ADDENDUM NO. :	Two (2)
BID DUE TIME AND DATE:	2:00 p.m.DST, Thursday April 9, 2020 (CHANGED)
SUBSTITUTION REQUEST: (in accordance with 00 21 13, 01 25 13, and 01 60 00)	Noon, Thursday April 2, 2020
BIDDER LAST QUESTIONS BY:	2:00 p.m., Friday April 3, 2020
LAST ADDENDUM ISSUED:	10:00 a.m., Monday April 6, 2020

- **NOTICE: BID DATE AND PROCEDURE CHANGE;**
 - **To provide a response to questions raised by Plan Holders; and,**
 - **To modify/clarify specifications & drwgs as a result of items above and identified by A/E Team.**
- Addendum 3 is scheduled to be released by 2pm Tuesday, 03/31/20 or earlier*; generally it addresses:
- Product Submittal clarification;
 - Signage clarification;
 - Door Schedule and Hardware Sets, Summary of Work, Alternates, update per this Addendum 02;
 - As well as address various Bidder questions.

RENOVATION WITH ADDITION TO BUILDING V ST. AUGUSTINE CAMPUS

ST. JOHNS RIVER STATE COLLEGE

A101

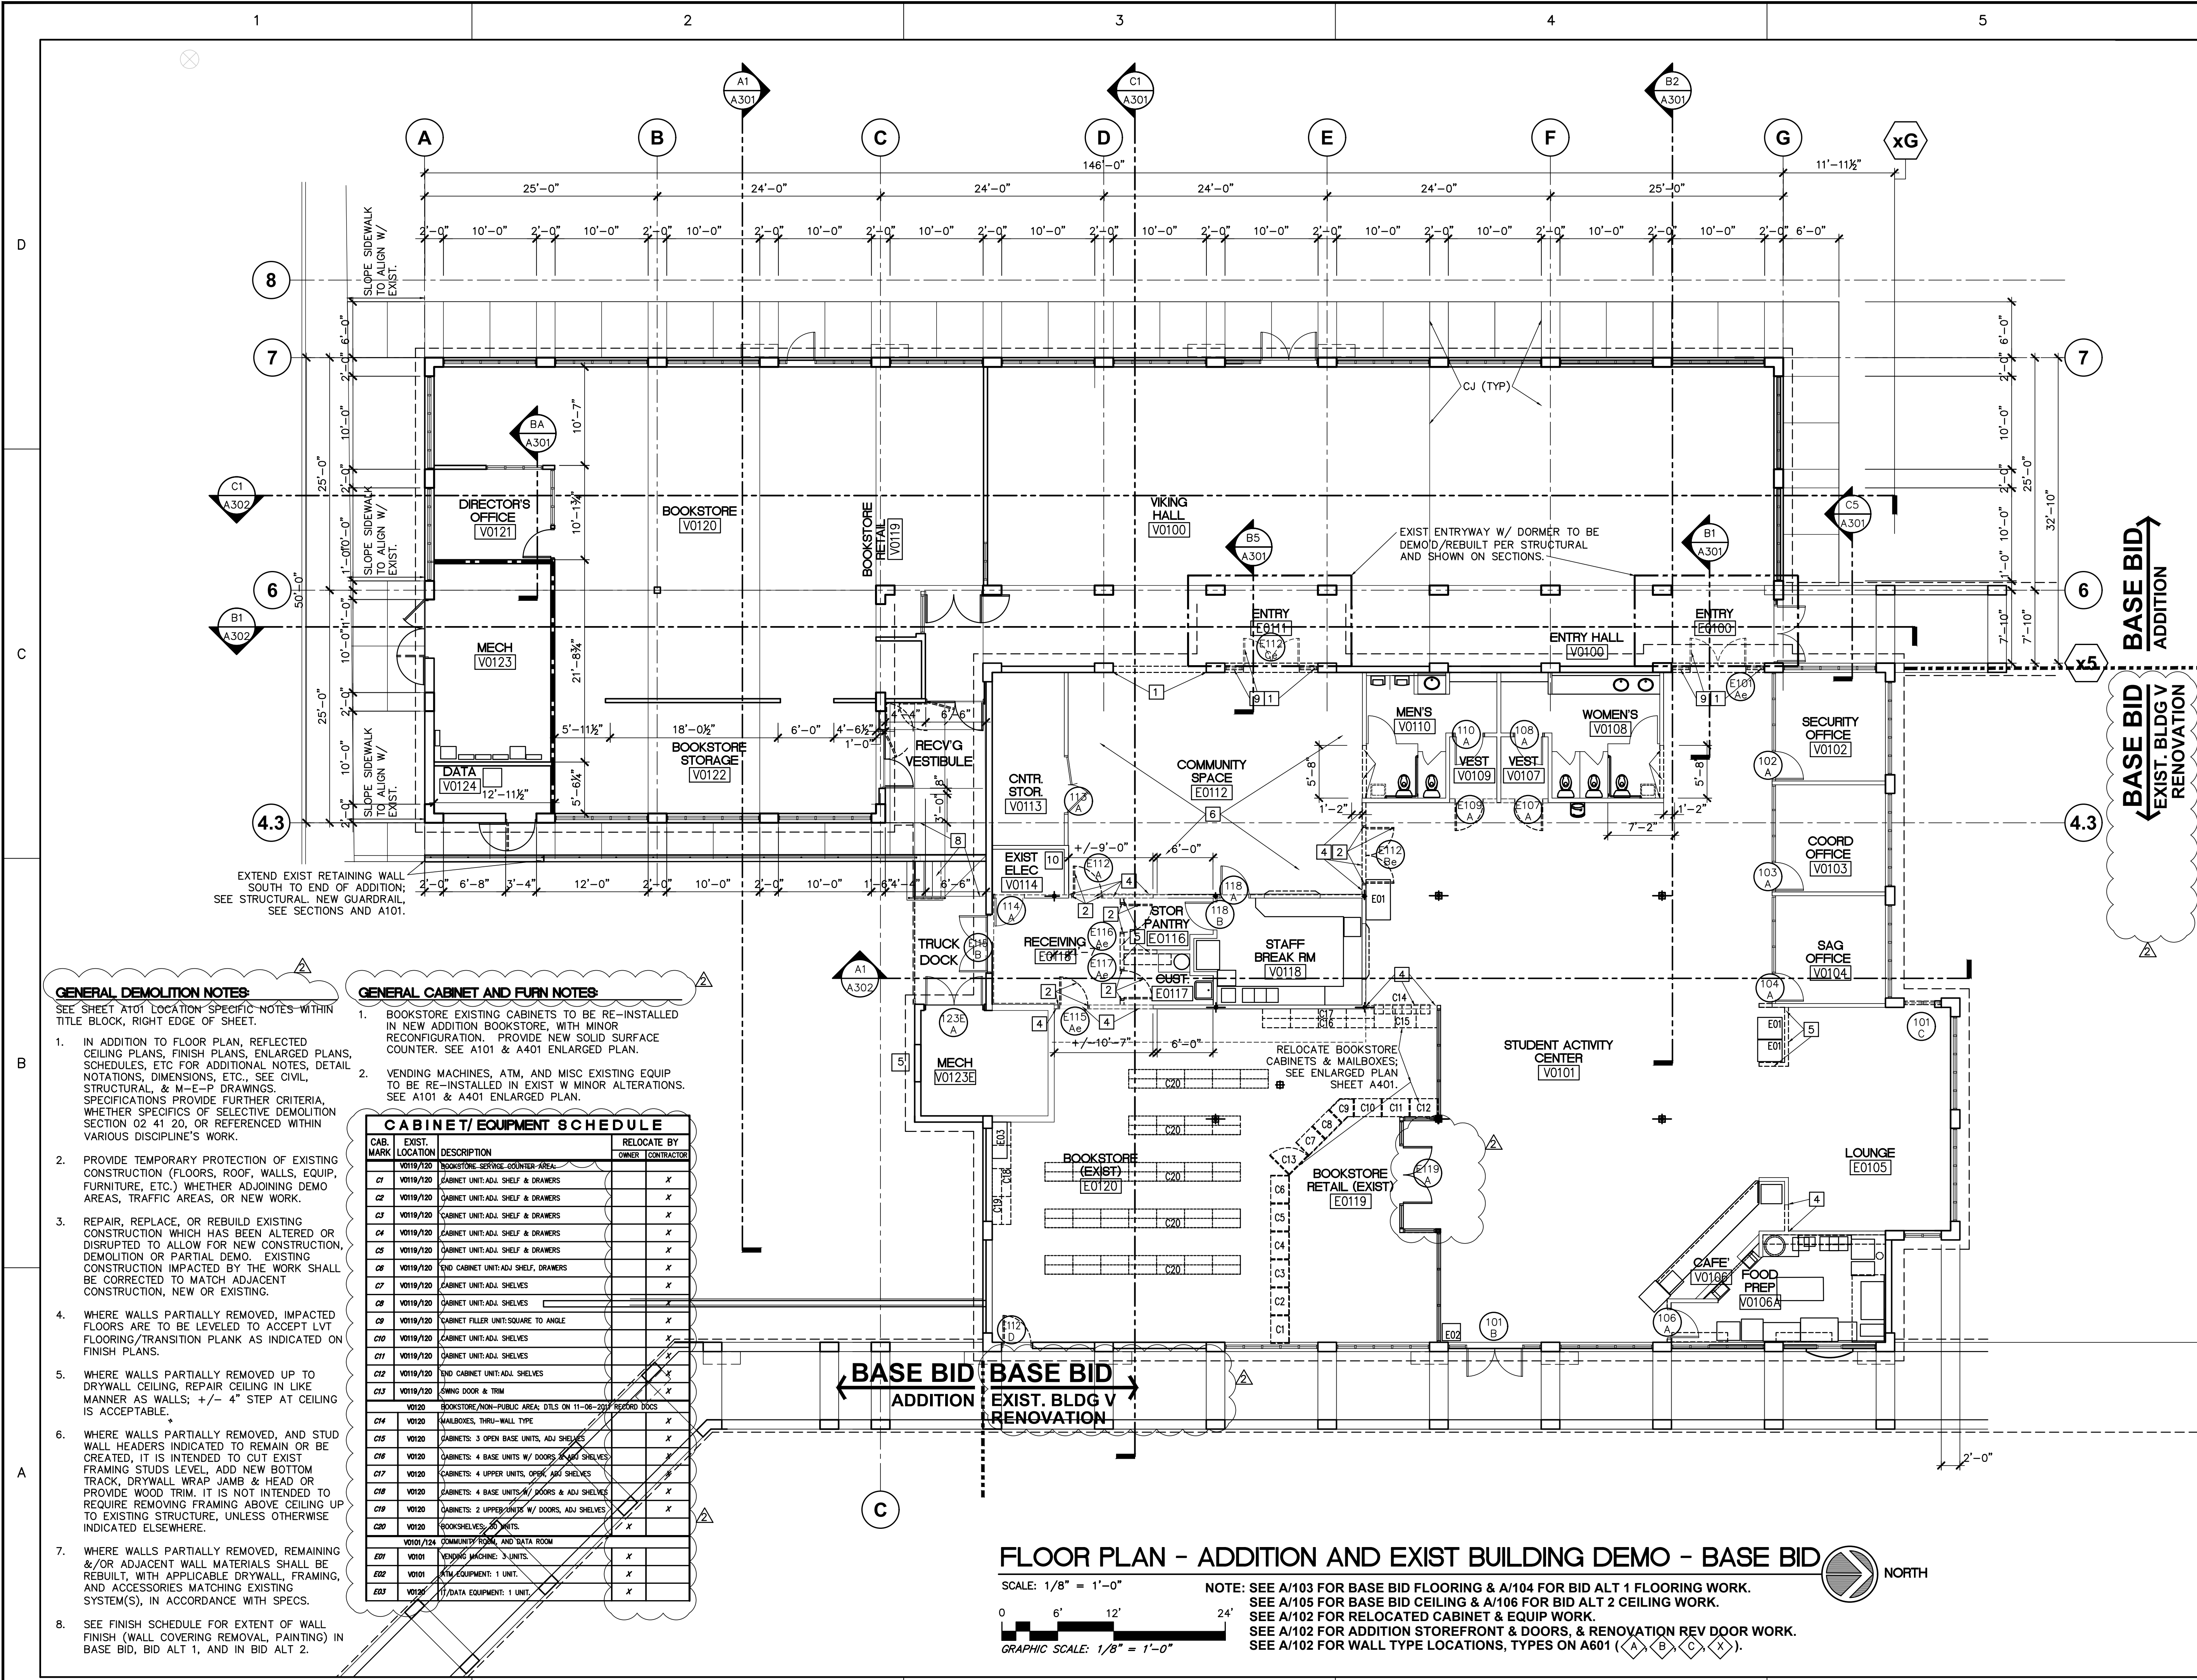
Q 01: It appears as though something is missing on the table shown on A101 and A102, bottom left corner. Are we to assume the Cabinet Schedule on A401 is the extent of that work?

Additionally regarding Storefront: to move non-essential Work within Existing Building V to Bid Alternate 3, see attached revised A101 and A501 where storefront pairs of doors work shifts from Base Bid to Bid Alternate 3:

- Existing single pair of doors in the new Community (existing Bookstore) are to remain unchanged in the base Bid; in Base Bid 3 is where the two new storefront door pairs replace the existing single pair.
- In the Base Bid, at the wall to be removed between the existing Community Room and existing Receiving: this opening is to become a cased opening capable of accepting storefront. Bid Alternate 3 now includes this new pair of doors with sidelite full 9' opening.
- In the Base Bid, once the mailboxes are relocated, relocate the existing pair of wood doors in existing Community Room (previously to be salvaged and turned-over to College) to this opening; delete in the Base Bid for these doors to be Storefront Pair.

A 01: Good eye; yes, the Cabinet Schedule on A401 is the extent of that work and applies to sheet A101 and A102. See attached A101 and A102.

- A101, A102 – Table notations (Q1/A1), as well indication of BASE BID at Existing Bldg V.
- A101, A102, A501 – Storefront changes (Q3/A3).

A102

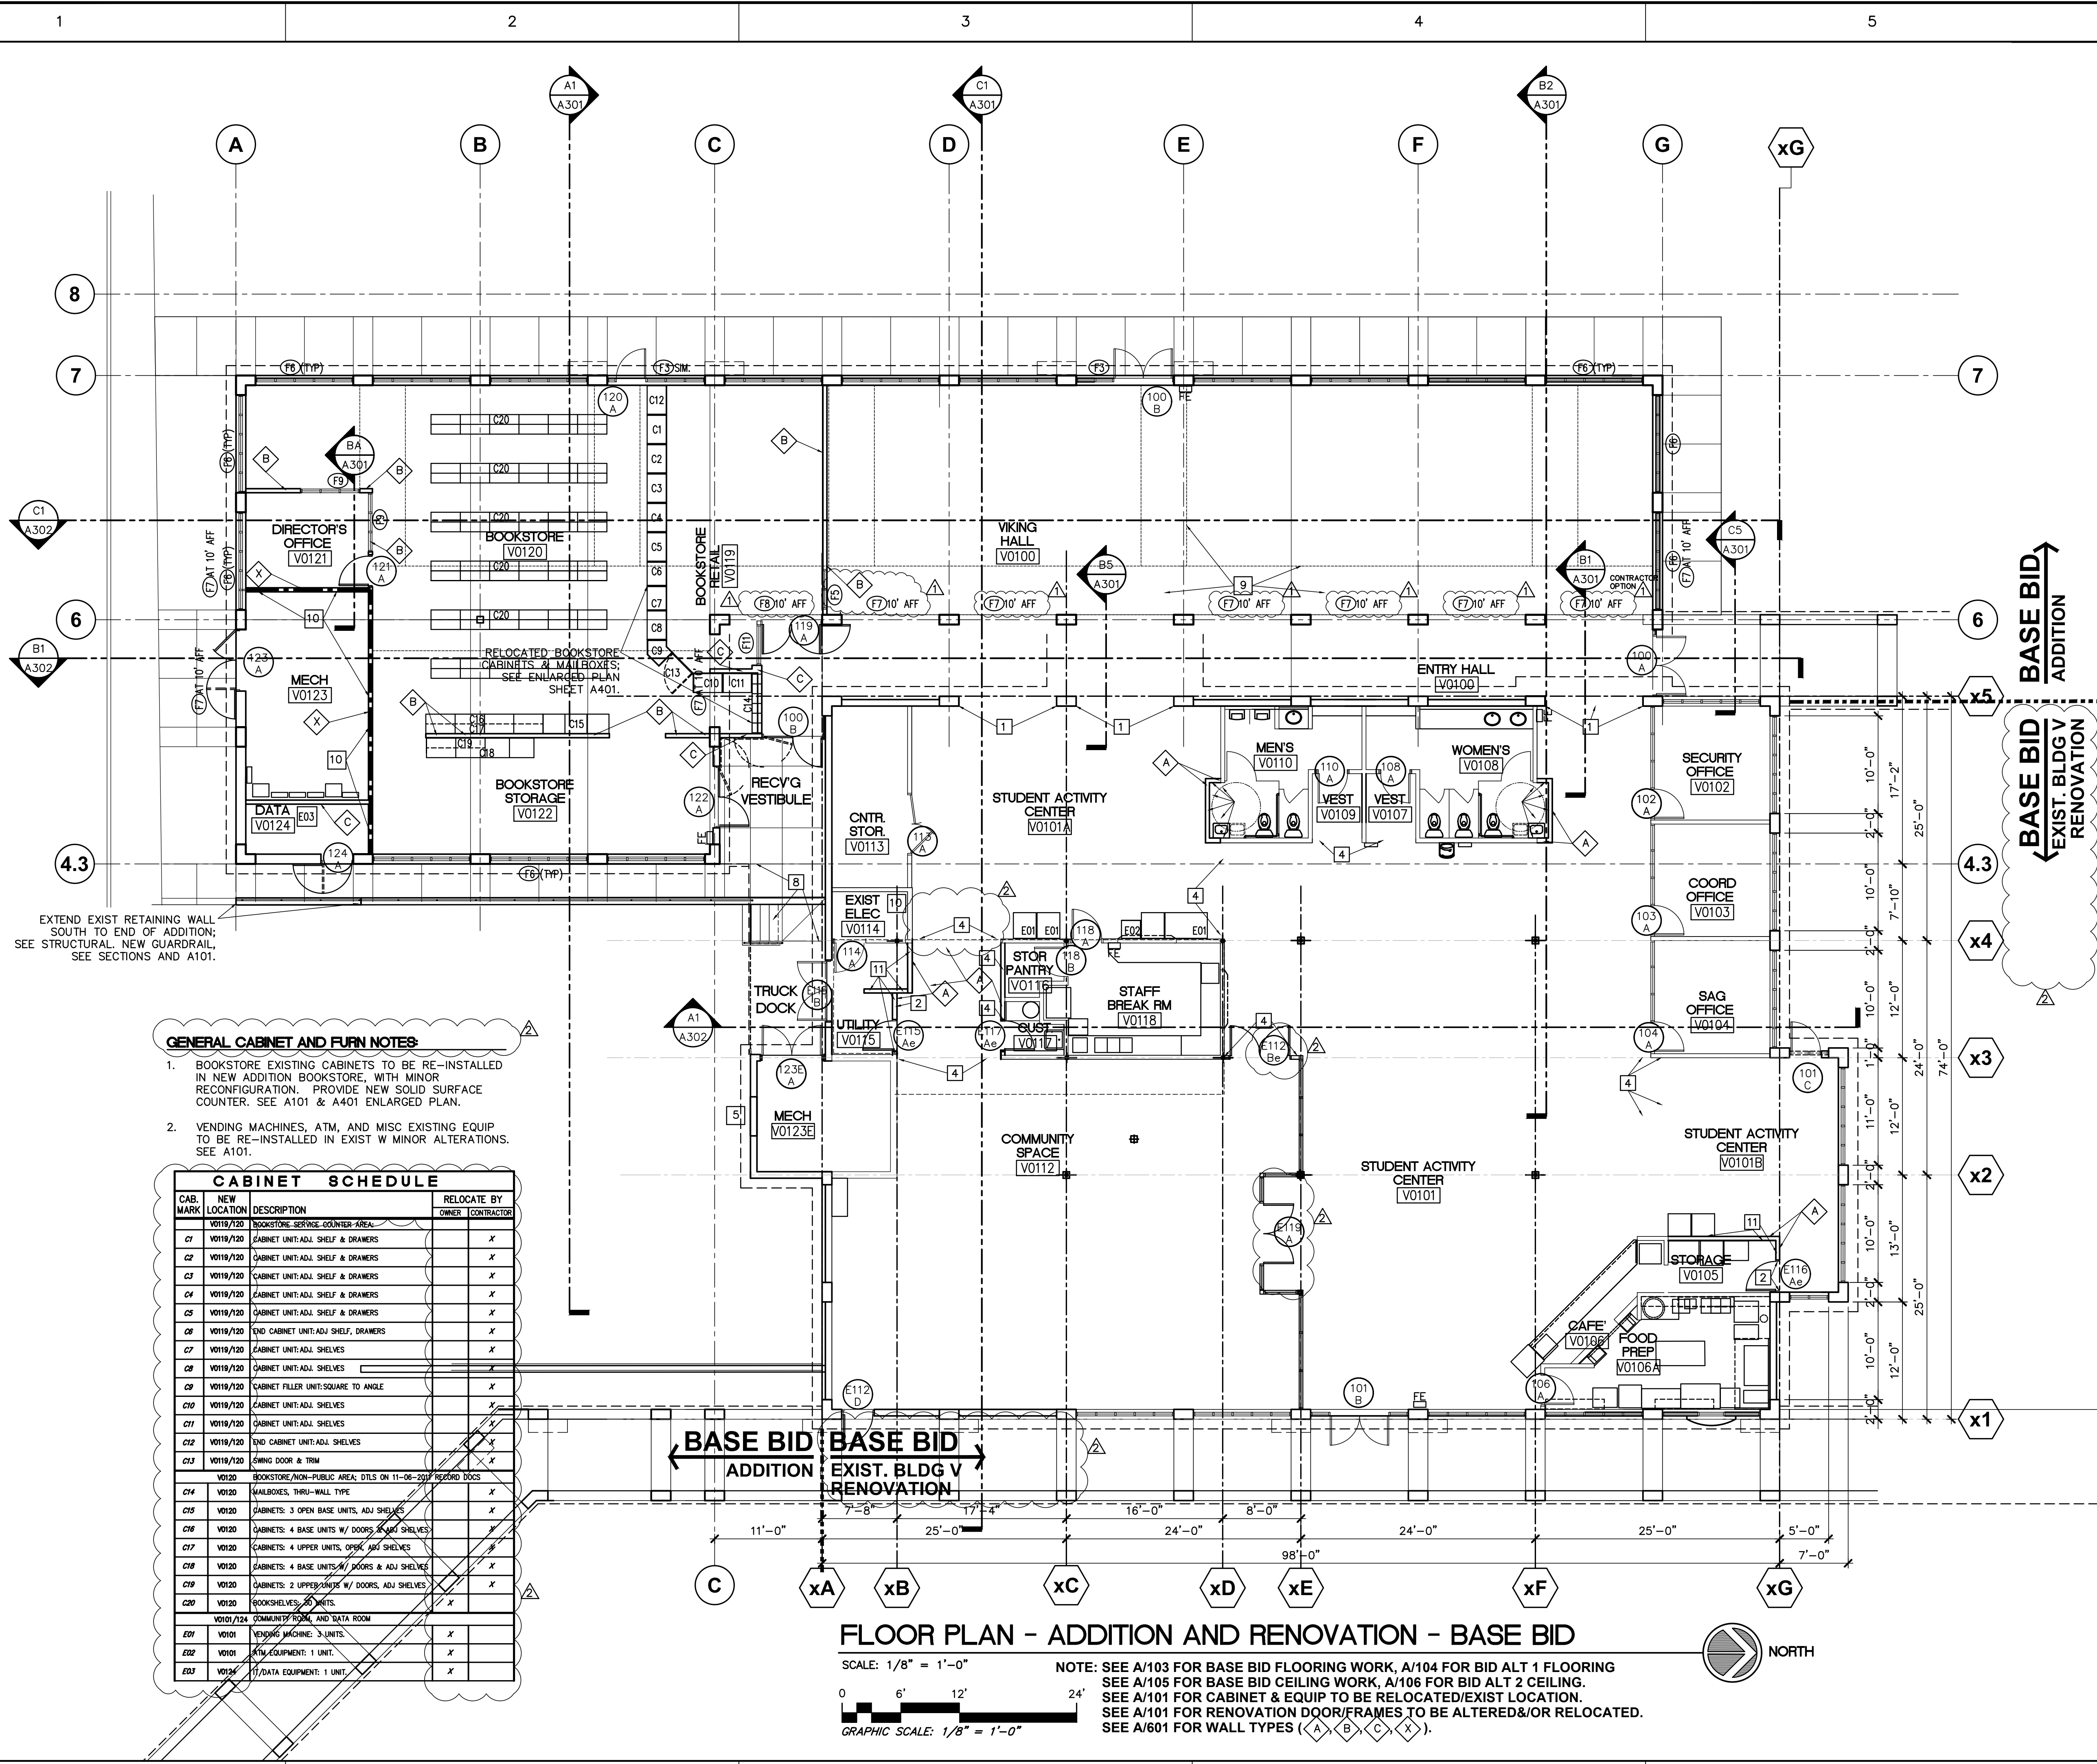
Q 03: With the change to the Bookstore/Viking Hall wall, is the perforated Panel needed for air-transfer?

Storefront: Addendum 01 revised sections/drawings in the Addition at the wall between Bookstore and Viking Hall where it was modified/opened-up, allowing area for return air, and negating the need for the perforated panel adjacent to the Bookstore entrance. This addendum modifies that storefront: delete F11 window type on A602 and replace F11 with F5 on plan A102.

Drawing LS101 -Fire Extinguishers (and references to A102): For clarification, Fire Extinguishers identified on LS101 take precedent over what is shown on A102.

Existing Building V: All but three (3) of the Fire Extinguishers shown within Existing Building V are existing; of these, two (2) new are cabinet w/ FE designation note ③, and one (1) new FE w/ bracket designation note ④.

Addition: In the Addition, there are two (2) cabinet w/ FE designation note ③, and one (1) new is ⑥ in Mechanical, however, ADD one (1) new type ⑥ adjacent to door 122A leaving Bookstore Storage.

A 03: No; delete perforated panel.
